Refining BREF review
– air emissions

Prepared by the CONCAWE Air Quality Management Group's Special Task Force on Integrated Pollution Prevention and Control (AQ/STF-70)

A review of emission and abatement technologies has been carried out to inform the review of the Reference Document for Best Available Techniques for the Mineral Oil and Gas Refining Industries (the BREF) which acts as a guidance to permit authorities when implementing the Industrial Pollution Prevention Control Directive.

Figure 6-1 Daily average fuel gas H_2S concentration after amine scrubbing

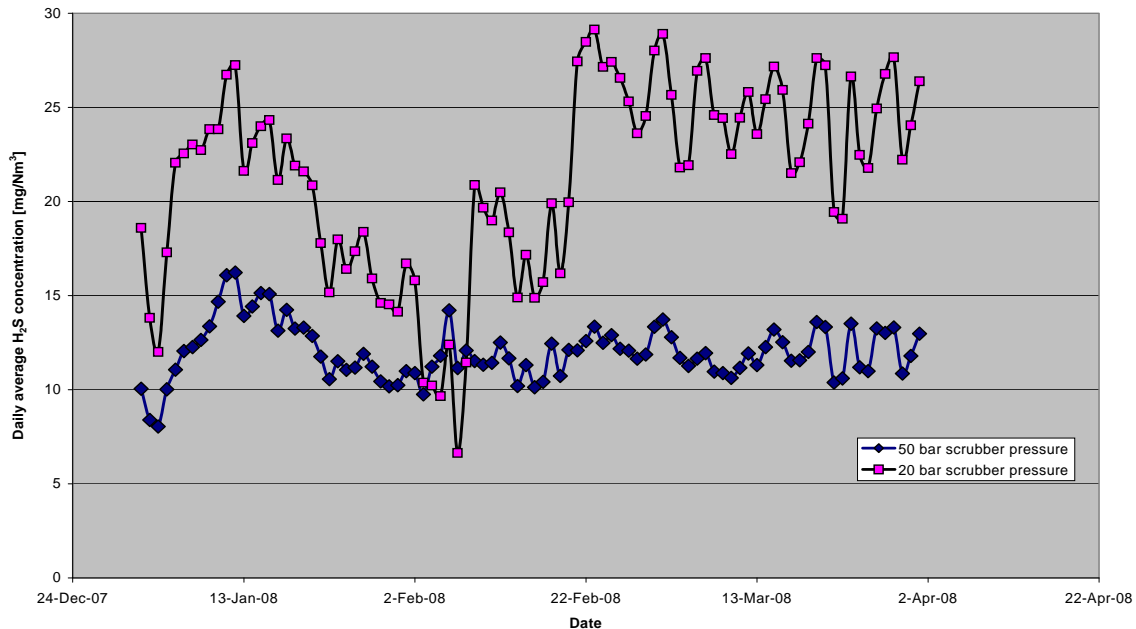
For the 20 bar system the H_2S concentration is <30 mg/Nm^3. For the 50 bar system this value is 17 mg/Nm^3. These are consistent with the calculated ranges shown in **Table 6-1**.

Based on **Table 6-1** the current BREF values correspond broadly to the middle of the operating range as it varies with temperature (noting that other sensitivities have not been tested) so we propose the following ranges:

1. Replace the current performance ranges in BREF paragraphs 2.10, 4.23.5.1 and the current AEL range in paragraphs 5.2.10 and 5.2.23 by the table below:

Fig. 7-1 Observed Sulphur Recovery ranges for European plants

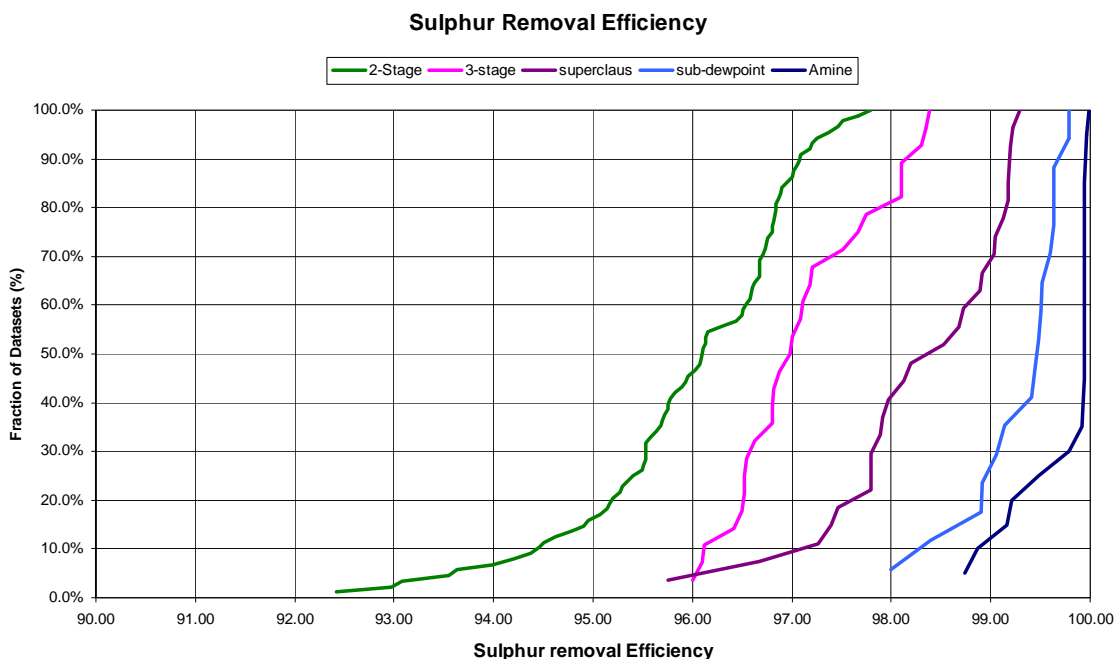
- Part of the real plant 2 and 3 stage Claus data do not meet the lower part of the current expected sulphur recovery range.
- A significant part of the observed Superclaus performance levels does not meet the ranges mentioned in Chapter 4.
- Nearly all amine based processes meet the current BREF Chapter 5 AEL range.
- Only about 50% of the sub-dewpoint units meet the Chapter 5 AEL range.
- Claus units and most catalytic direct oxidation units don't meet the Chapter 5 AEL range.
- The expected sulphur recovery level, spelled out in BREF 4.23.5.2.2. is too optimistic for some processes, mainly in the category of the oxidation and sub dew-point technology.

- It is proposed to change the current Chapter 5 AEL range for sulphur recovery from 99.5-99.9% to 99.0-99.9% for new facilities and to 98.0-99.9% for existing units (par. 5.2.23). This proposal can be motivated as follows:
